Project No. 12091-01

**Subject: Preliminary Geotechnical Evaluation and Response to City Review Comments for Proposed San Pedro Distribution Center, 1599 W. John S. Gibson Boulevard, Los Angeles, California**

## **5.0 RESPONSE TO CITY REVIEW COMMENTS**

PROJECT NAME	San Pedro Distribution Center
PROJECT NO.	12091-01
ENG. / GEOL.	BTZ / KBC
SCALE	1" = 40'
DATE	March 2019

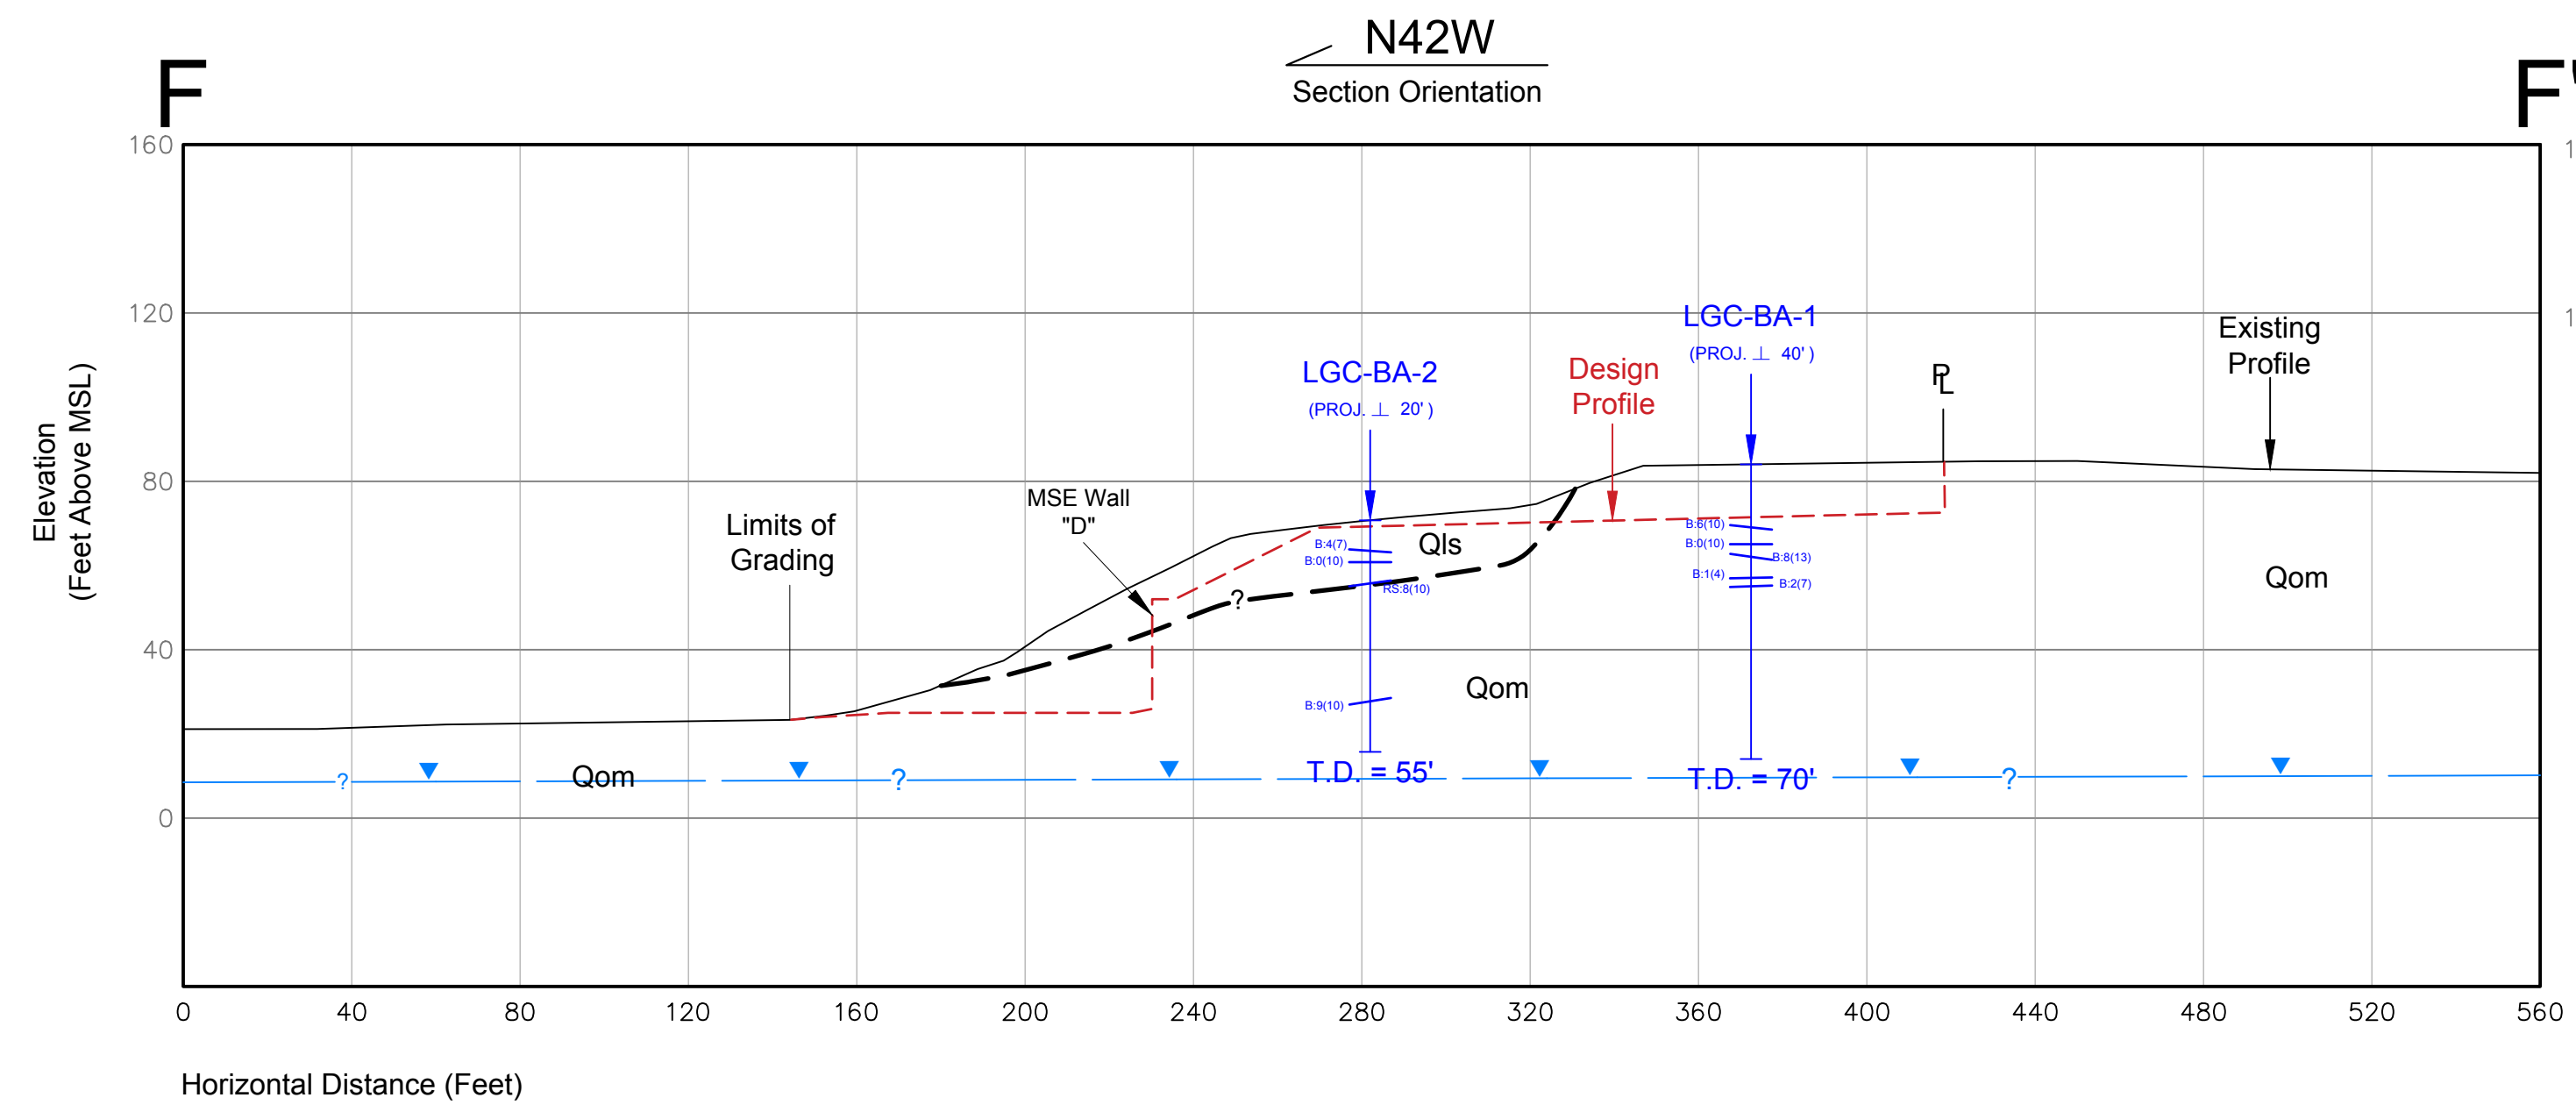
“Provide a geologic map and cross sections that are based upon conceptual grading or site development plans, to illustrate all proposed and existing contours relative to the planned grading and/or construction, along with all off-site slopes and conditions that could adversely affect the stability or safety of the site (7006.3.2). The geologic map and cross sections shall depict the top and bottom of slopes; lithologic contacts; bedding attitudes; locations of slumps, landslides, or faults relative to the subject site; existing and proposed topographic profiles; existing and proposed structures; and, required Code setbacks. (7006.3.2)”

Refer to the attached Geotechnical Map and Geotechnical Cross Sections (Sheets 1 through 5). No building structures are planned for the site.
